**CITY OF NORTH ST. PAUL PLANNING COMMISSION
REGULAR MEETING AGENDA
THURSDAY, FEBRUARY 6th, 2020
6:15 PM**

A. Rezoning, Major Subdivision (preliminary plat), and Preliminary Planned Unit Development – 2242 7th St. N. and 2231 6th St. N.

Date: 1/30/2020
To: Planning Commissioners
From: Erin Perdu, AICP, City Planner
Ryan Krzos, AICP, Planning Consultant
CC: Scott Duddeck, City Manager
Debra Gustafson, Administrative and Community Services Director
Re: Preliminary Plat for property at 2242 7th Street N and 2231 6th Street N; and Rezoning from R-1 to R-2 and Preliminary Planned Unit Development Review for 2242 7th Street N

PRELIMINARY PLANS FOR THE
7TH STREET TOWNHOMES
NORTH ST. PAUL, MN
JANUARY, 2020

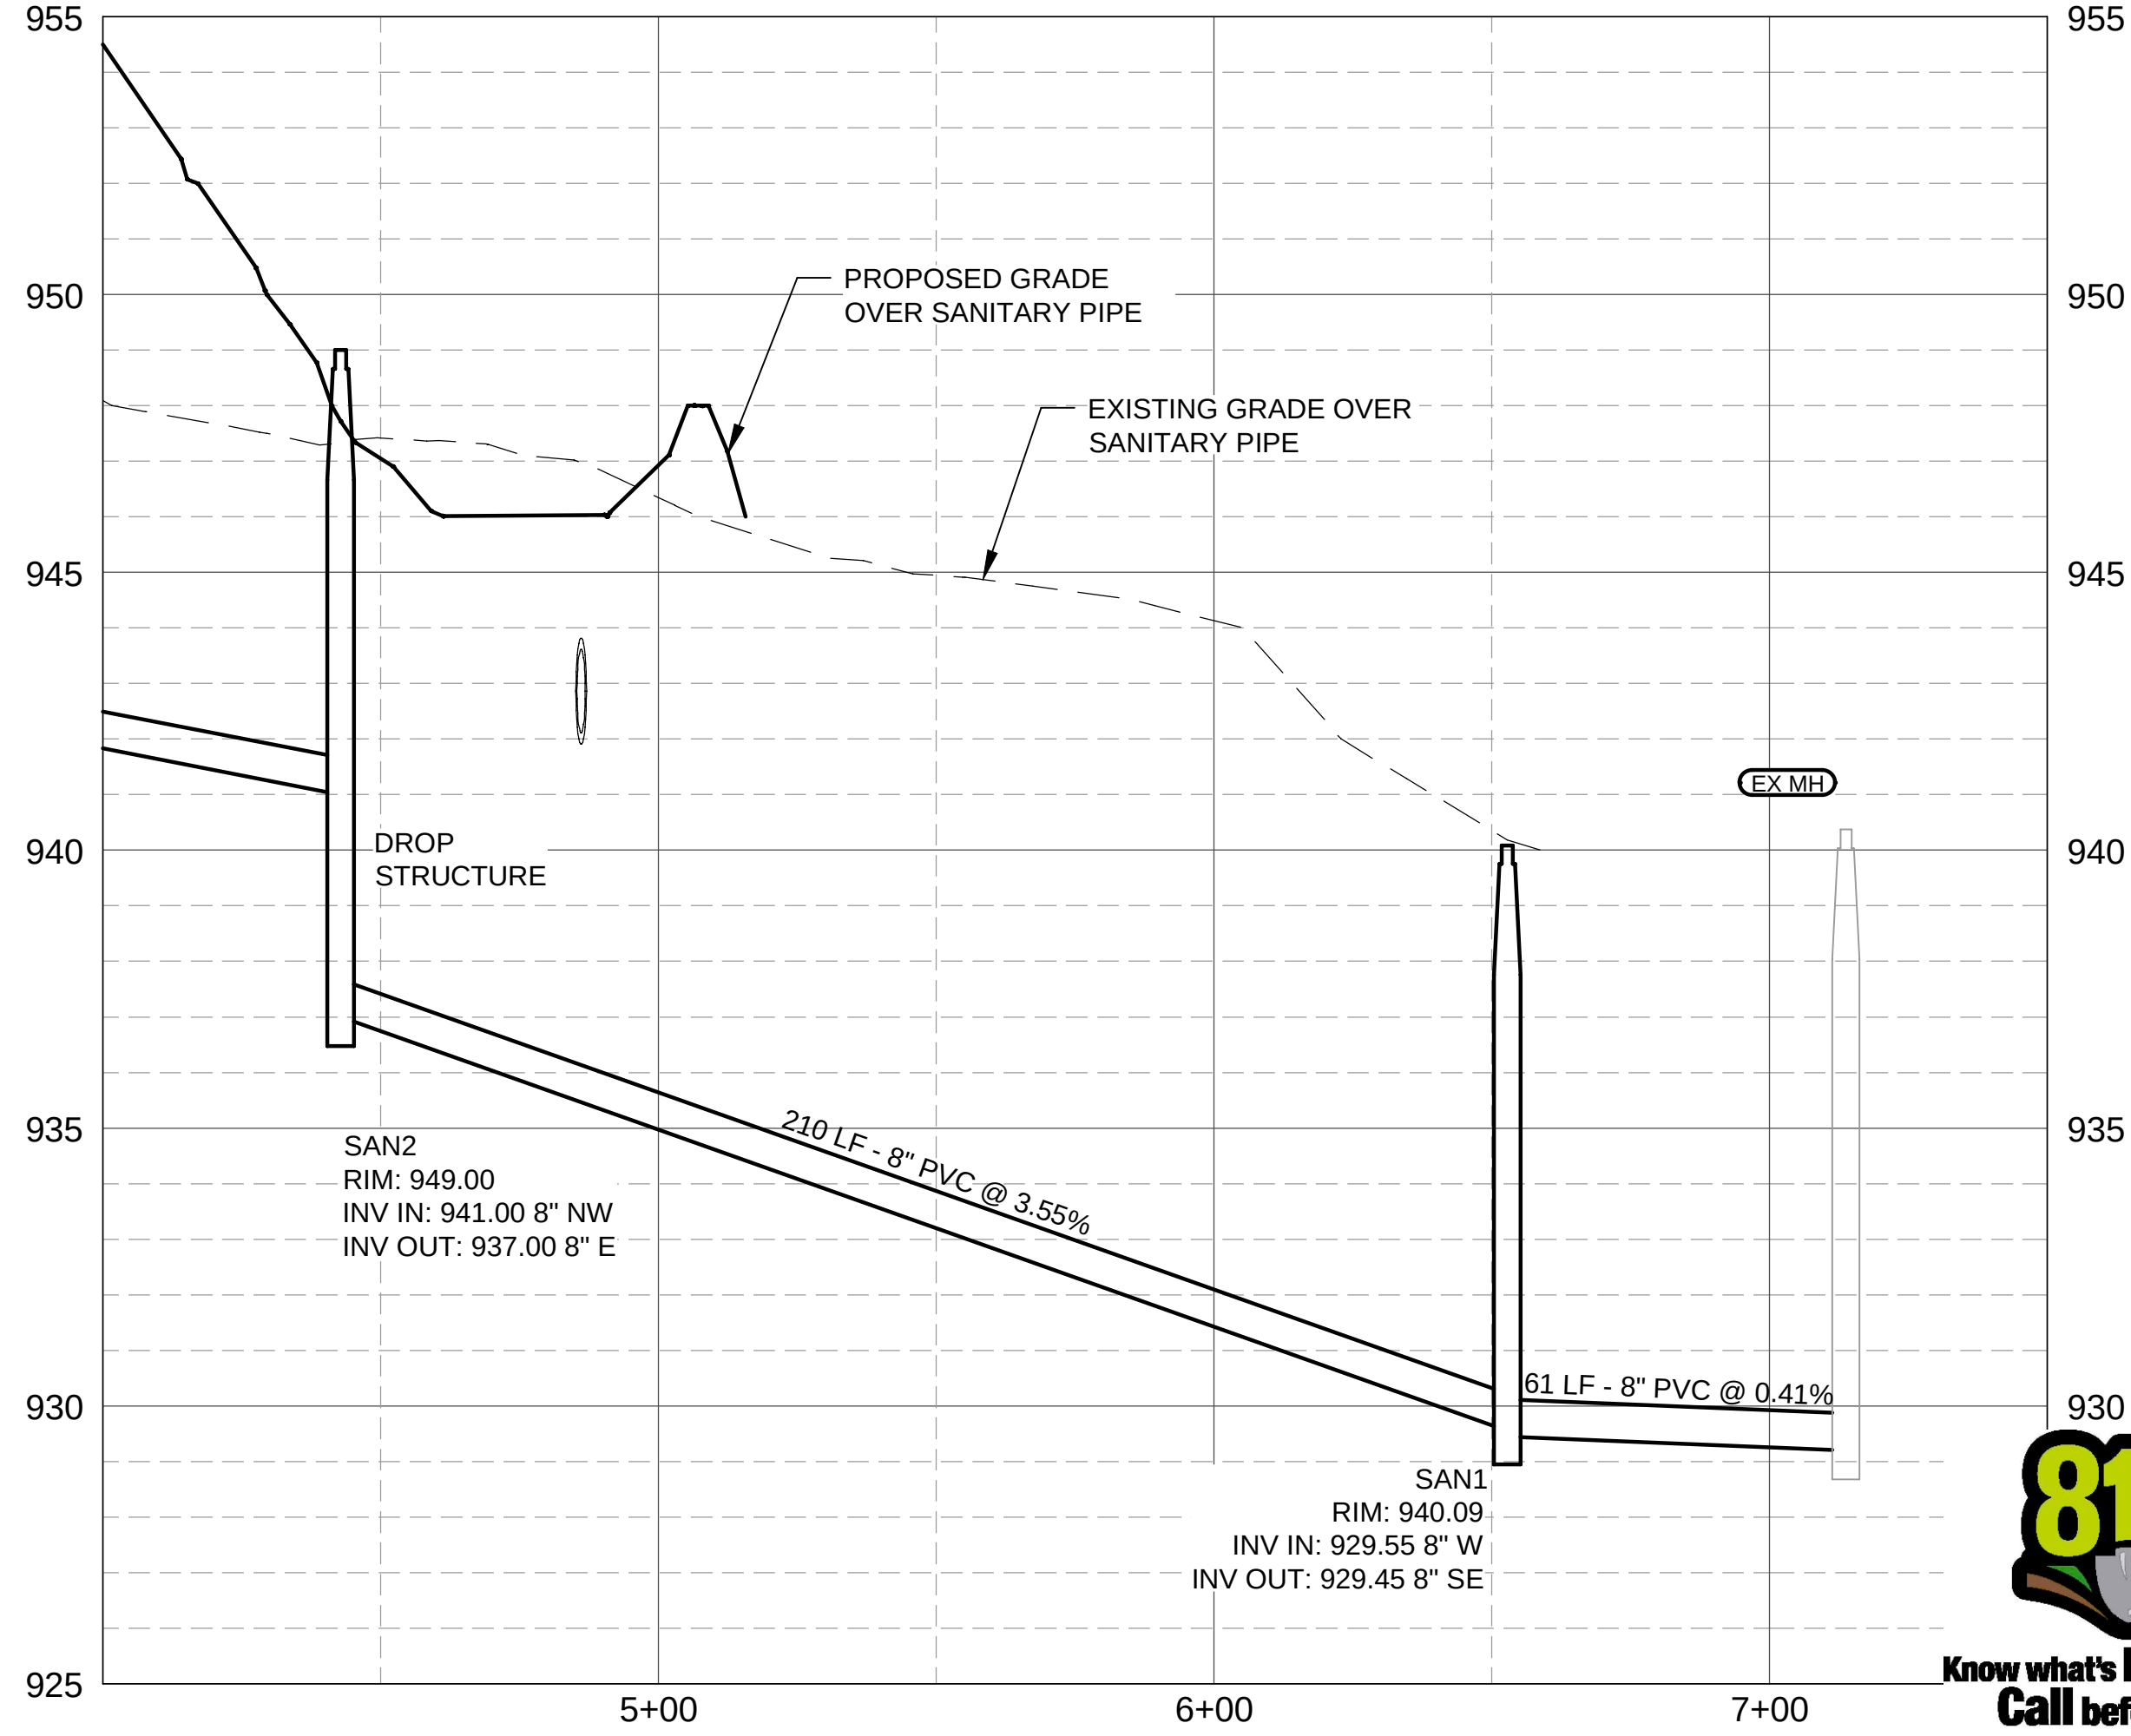
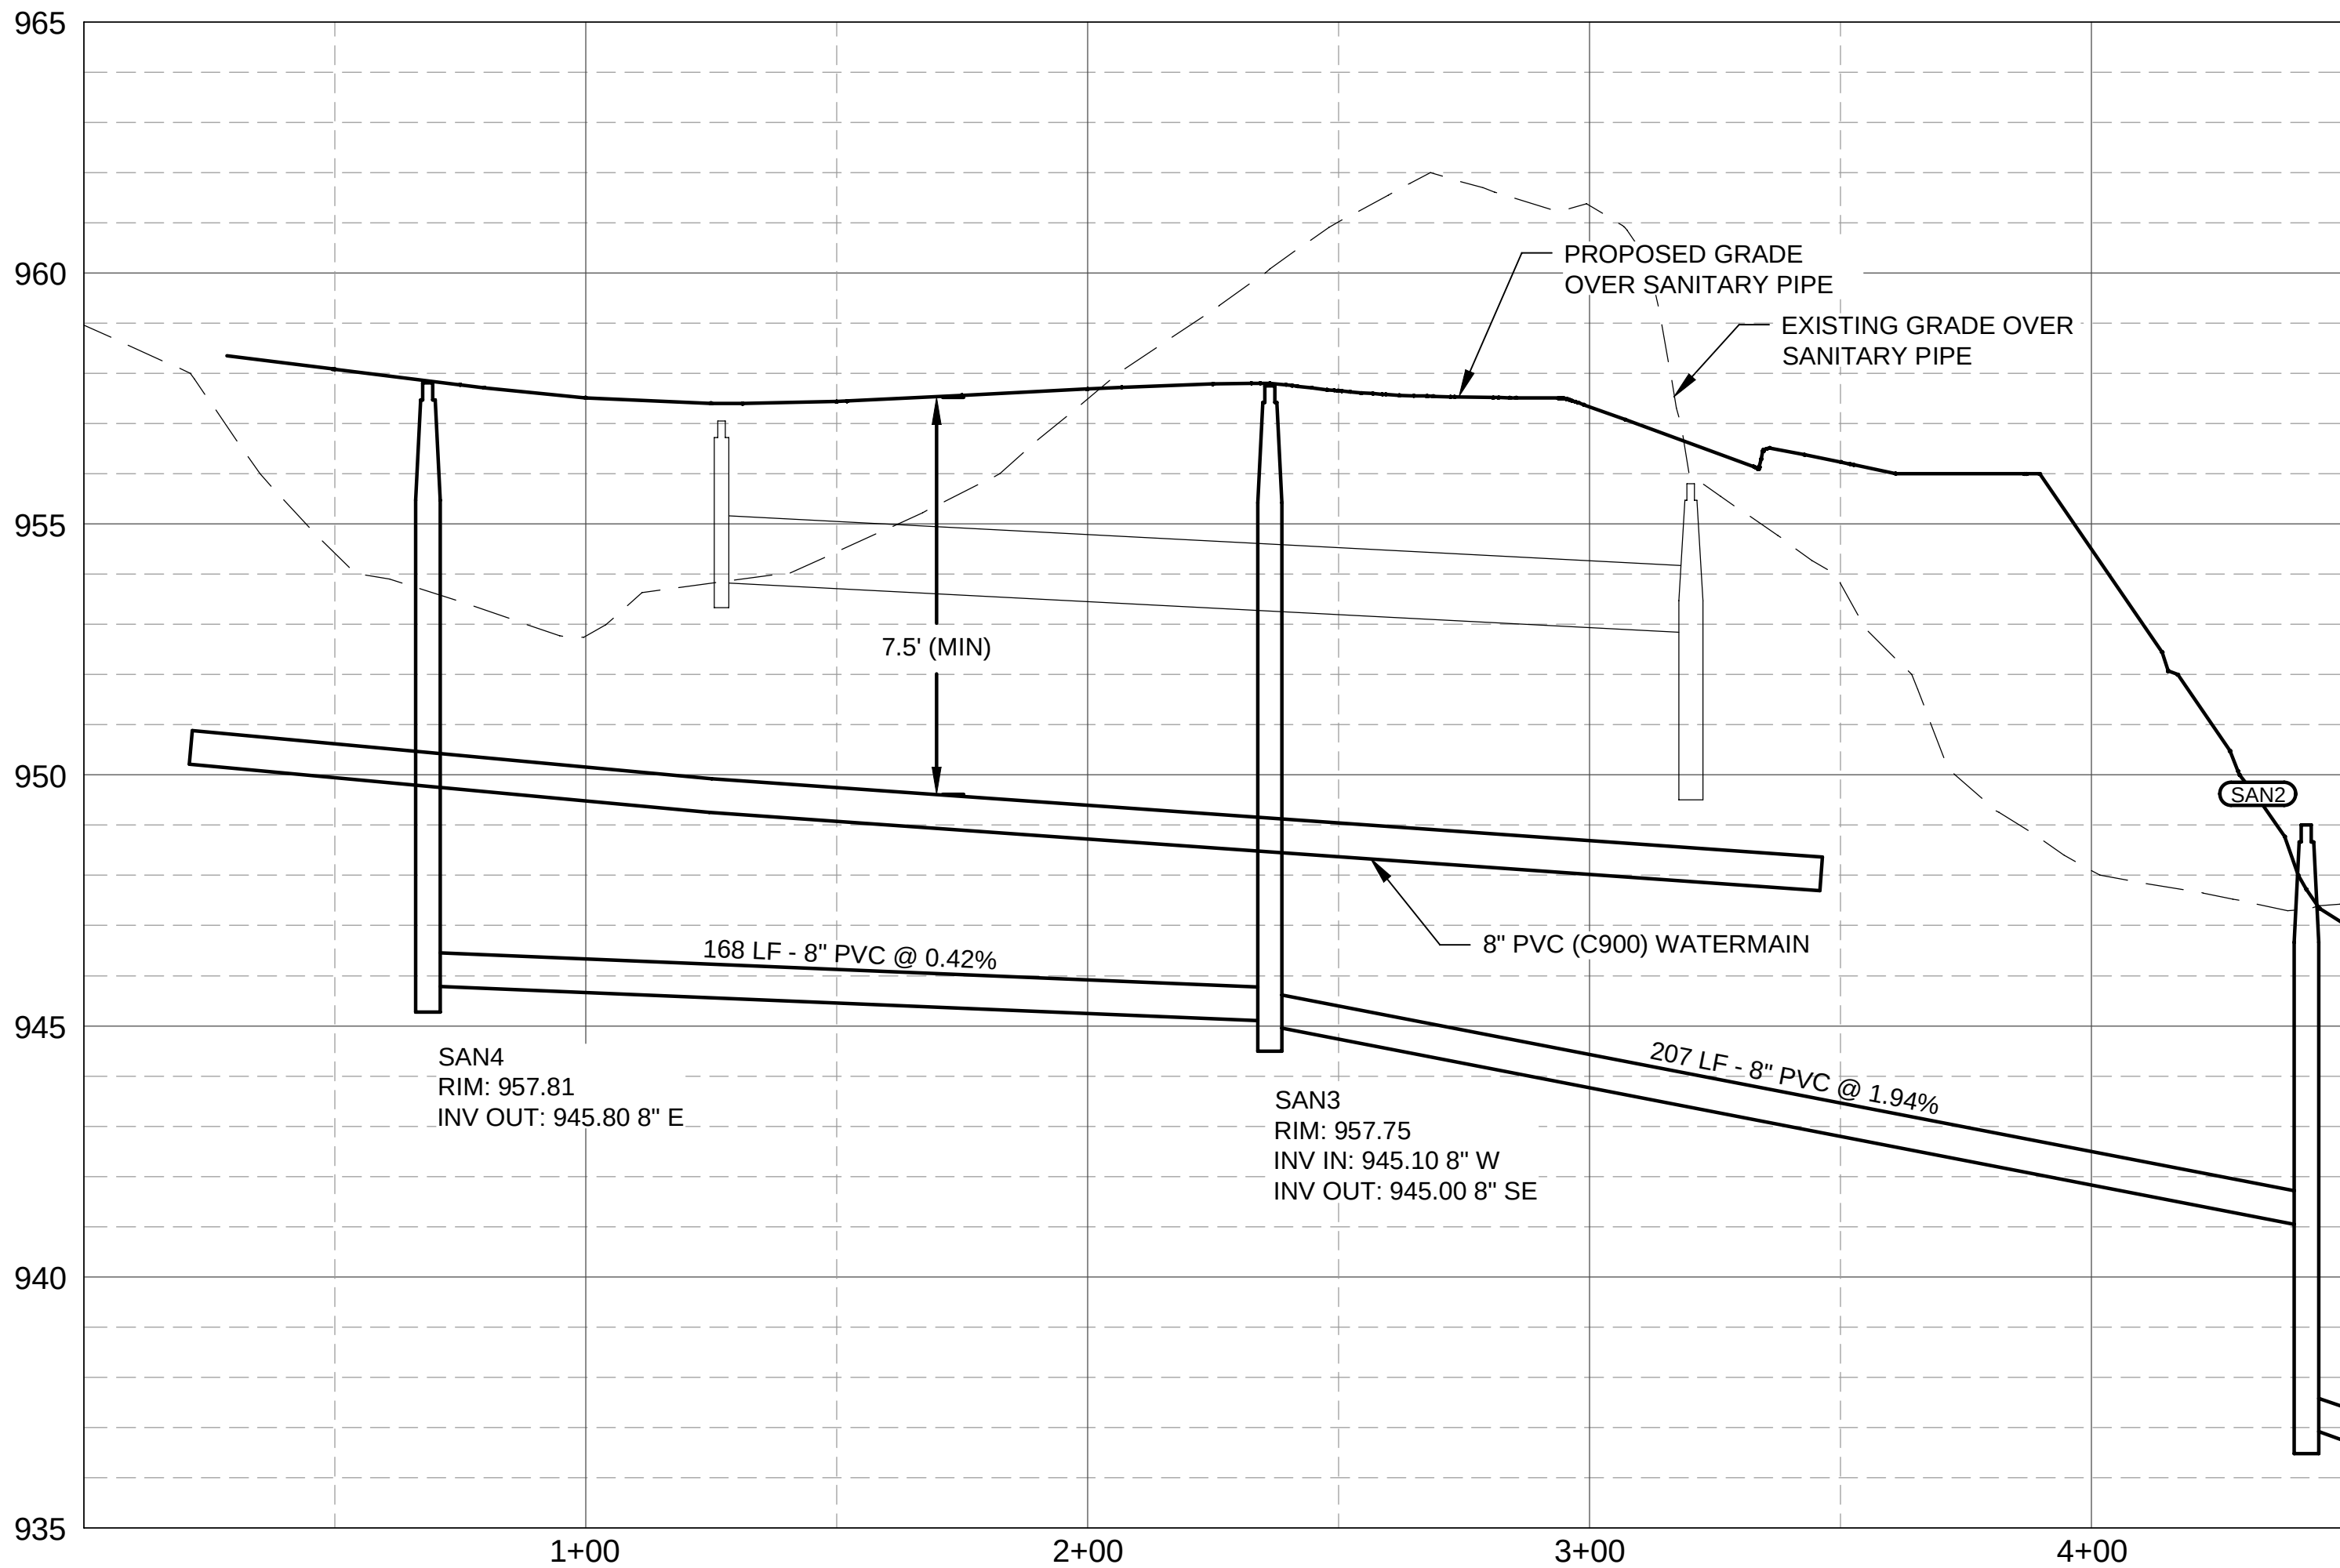
1. Note 1/C72 is shown in the wrong location.
2. Show sanitary and watermain in plan view (similar to storm on Sheet C40).
